Parkway Valley LRD

Stage 1 Stormwater Audit

231171-PUNCH-XX-XX-RP-C-0009

May 2026

| Title: PROPOSED DRAINAGE LAYOUT - SHEET 2 | | | |

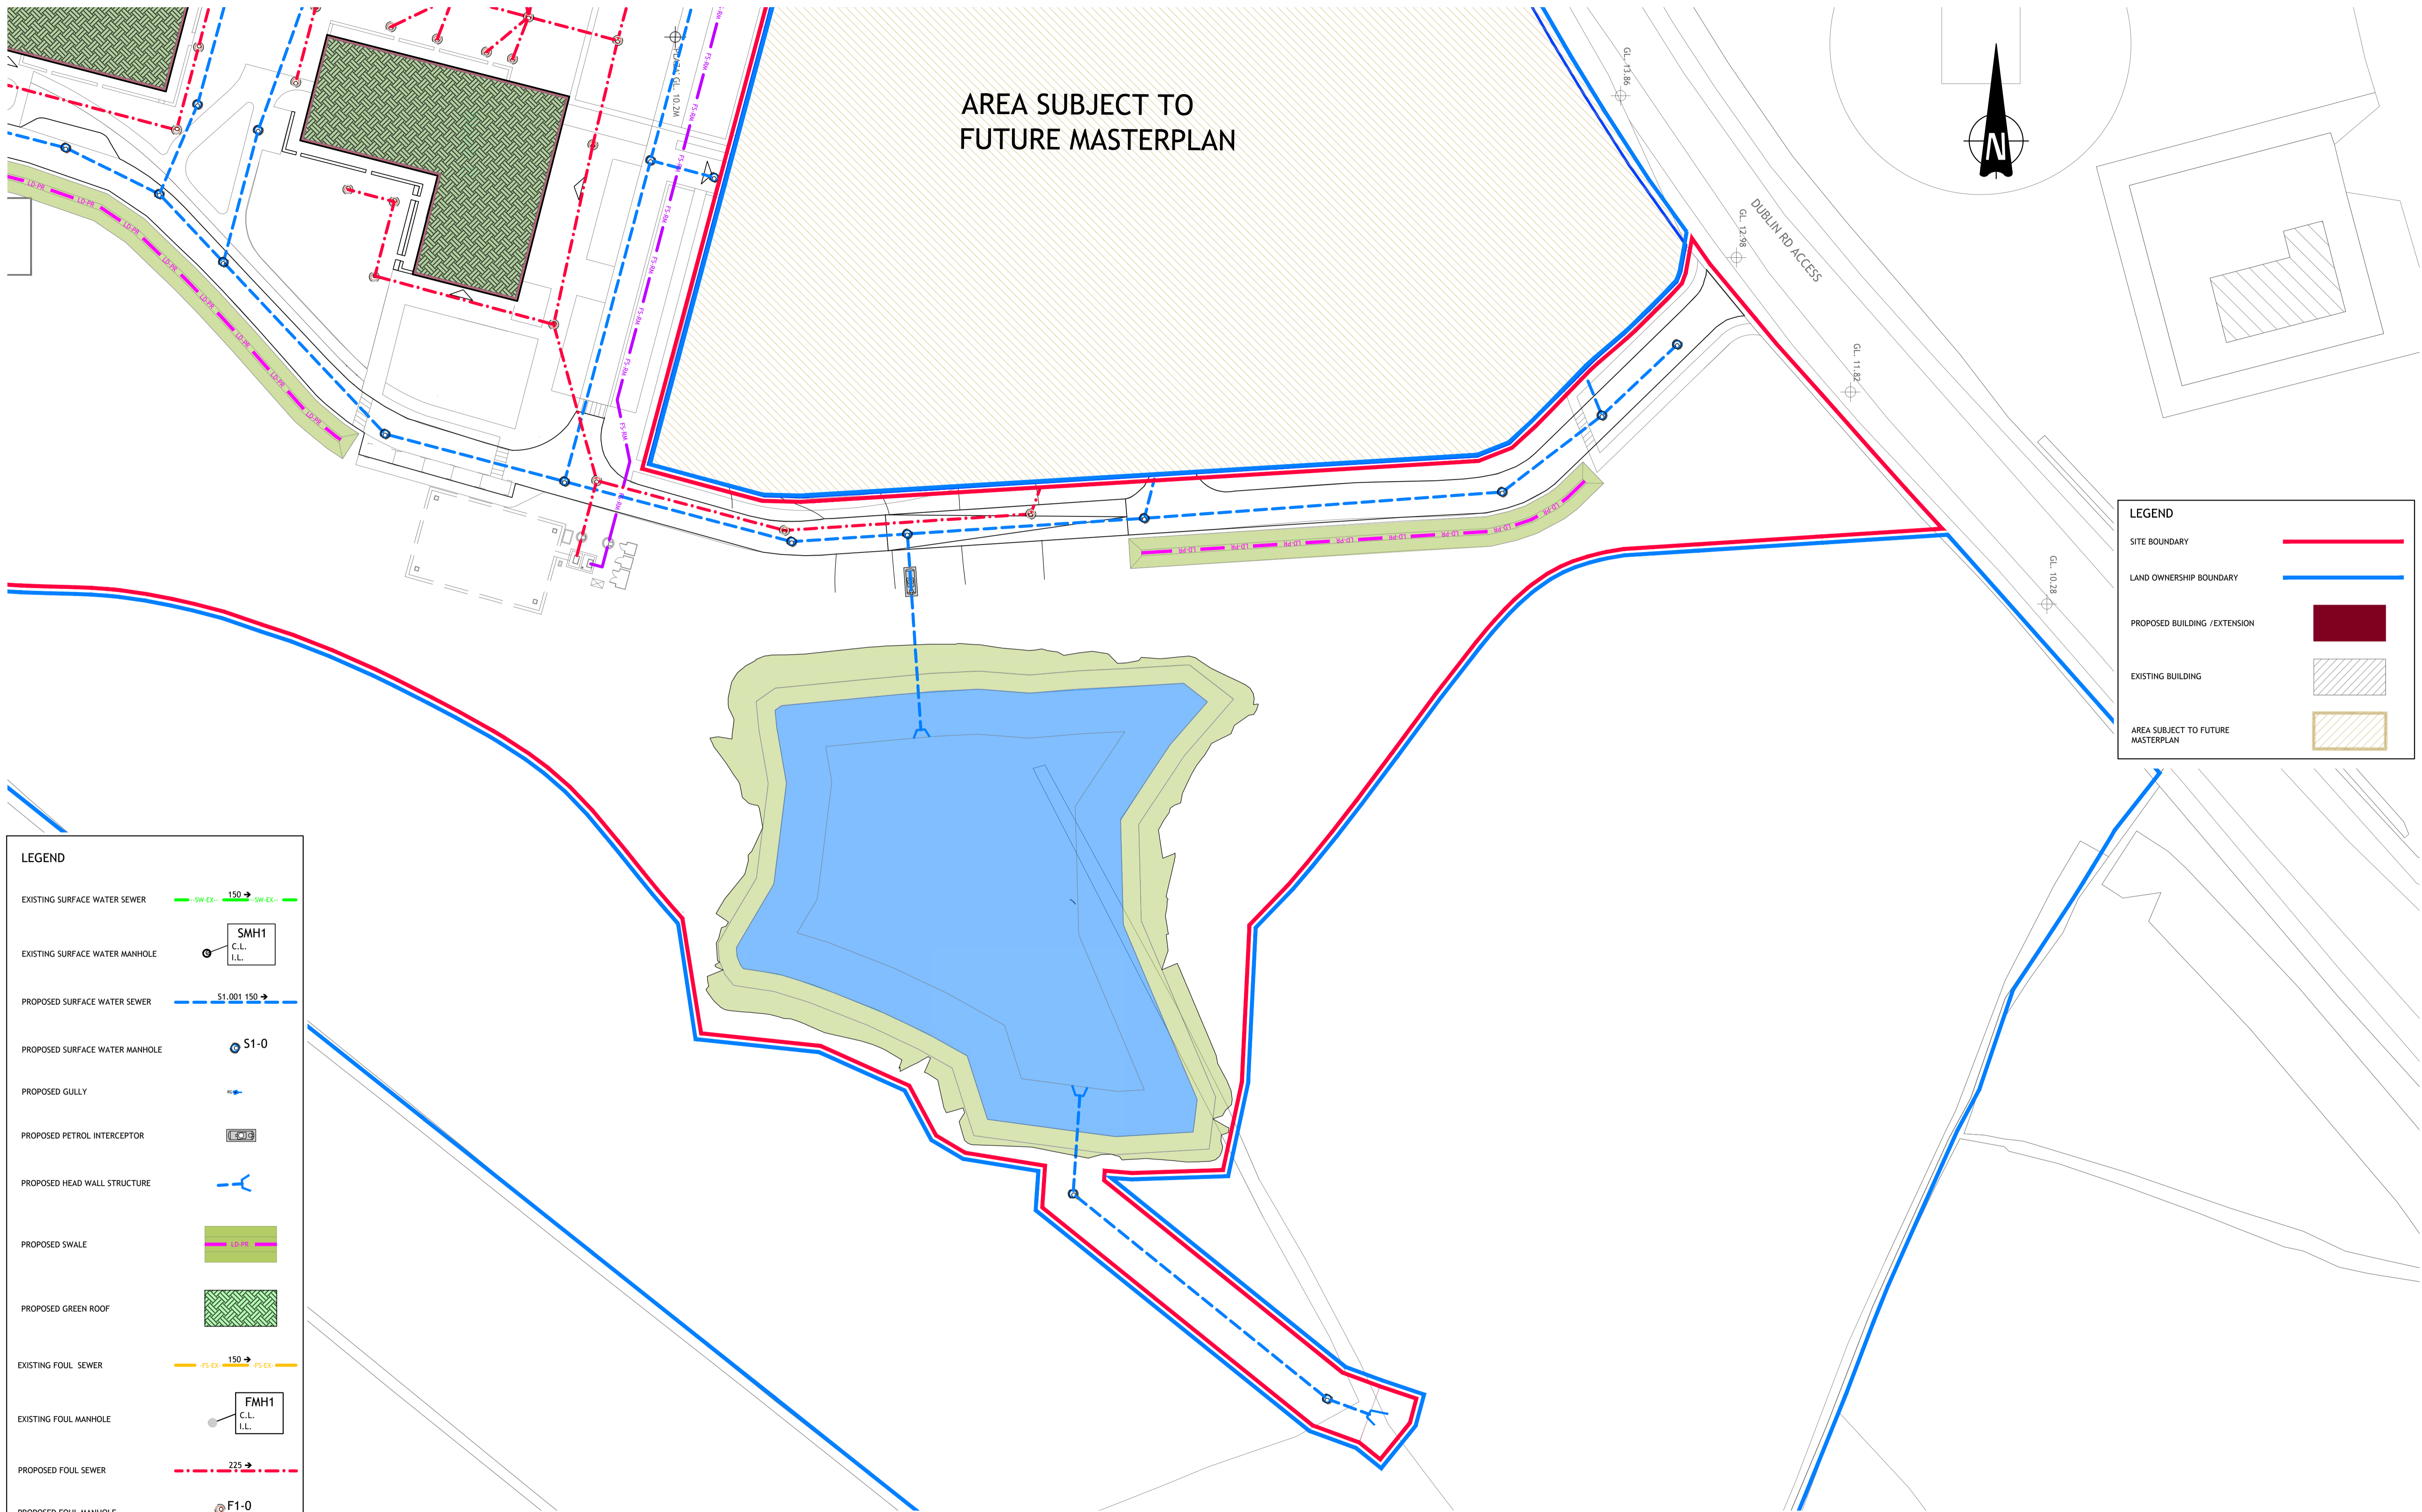
Problem: It has been noted that the *Proposed Drainage Layout* drawings (231171-PUNCH-XX-XX-DR-C-0101 and 0102) do not include essential information for the surface water network. Specifically, the manholes are not labelled with their names, cover levels and invert levels, and the pipe links do not show link names, flow directions, or gradients. Labels for flow control devices (device type and discharge limits), attenuation (storage capacity) and proprietary devices (device type) are not indicated as well.

Recommendation: Scheme designer to revise the Proposed Drainage Layout drawings to improve clarity and ensure they can be used in conjunction with related documentation i.e. Drainage Longitudinal Sections, Causeway Flow Results, etc.

| Title: PROPOSED SUDS LAYOUT - SHEET 1 | | | |

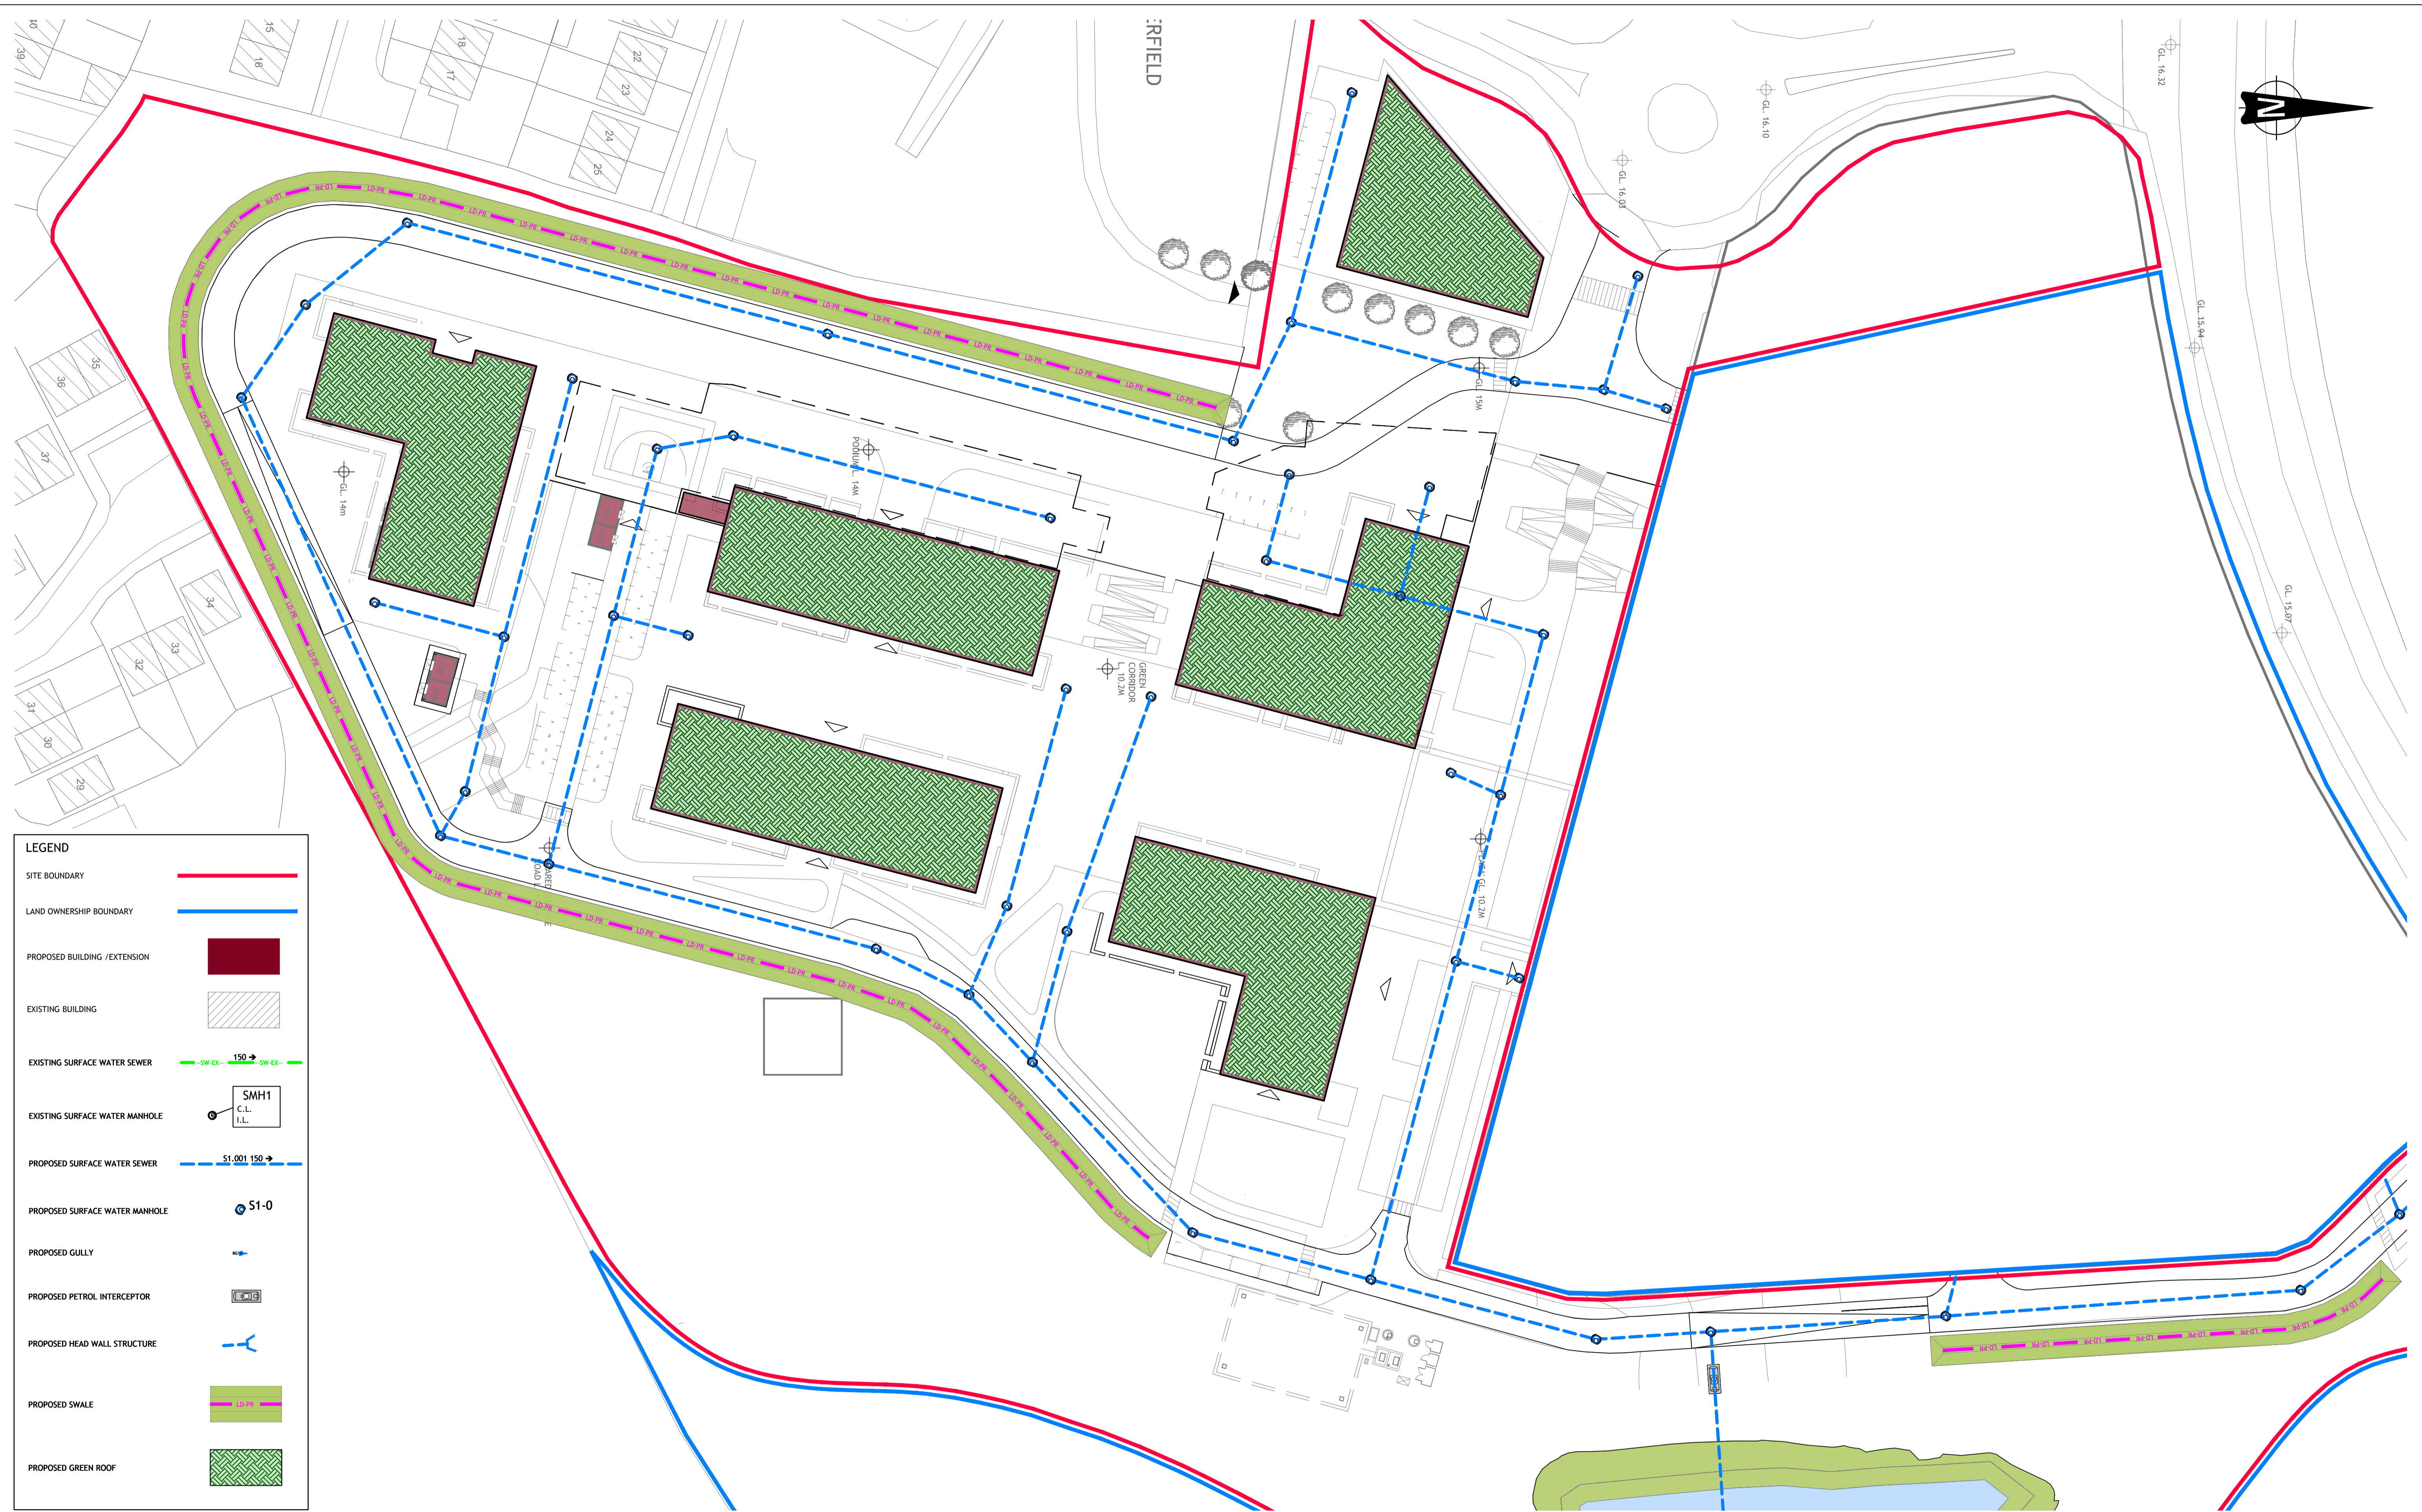
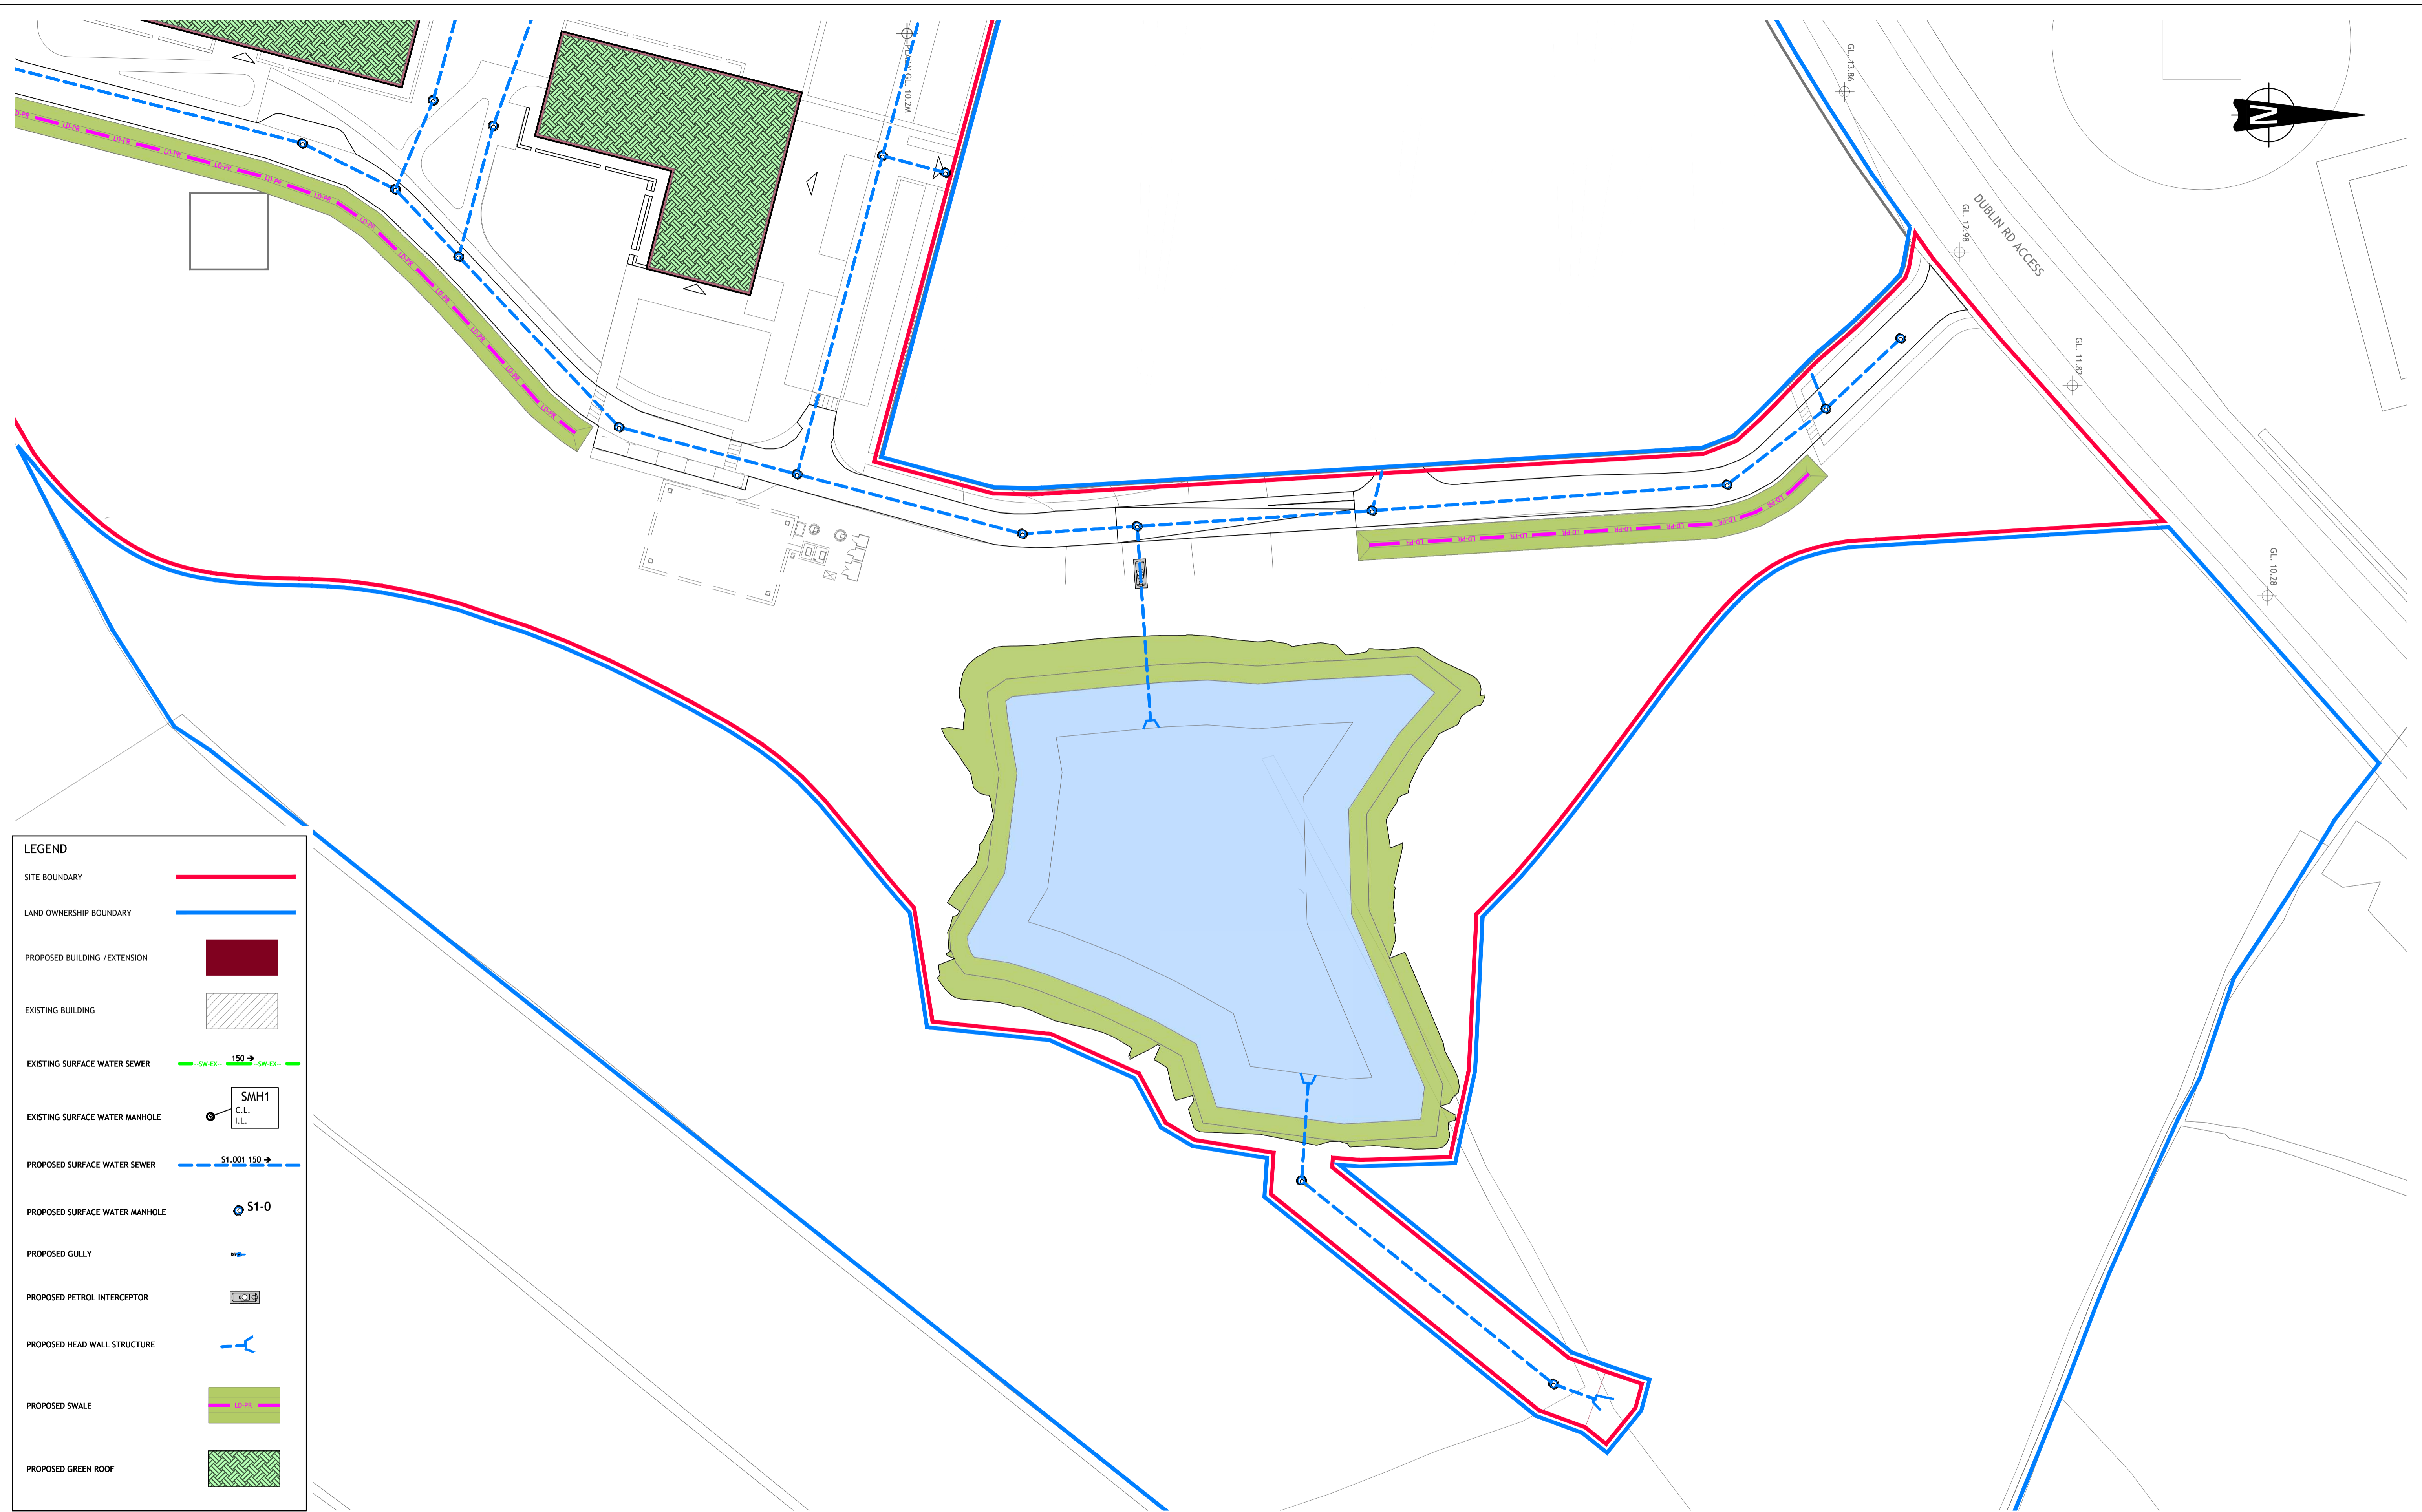
Problem: Section 2.3 of the Engineering Planning Report lists Rain Gardens, Infiltration Trenches and Tree Root Systems as part of the proposed SuDS measures. However, the locations of these measures are not clearly indicated in the SuDS Layout drawings. Furthermore, there is no evidence of the Typical details for infiltration trenches in the provided documentation.

Recommendation: Scheme designer to clarify and rectify where necessary.
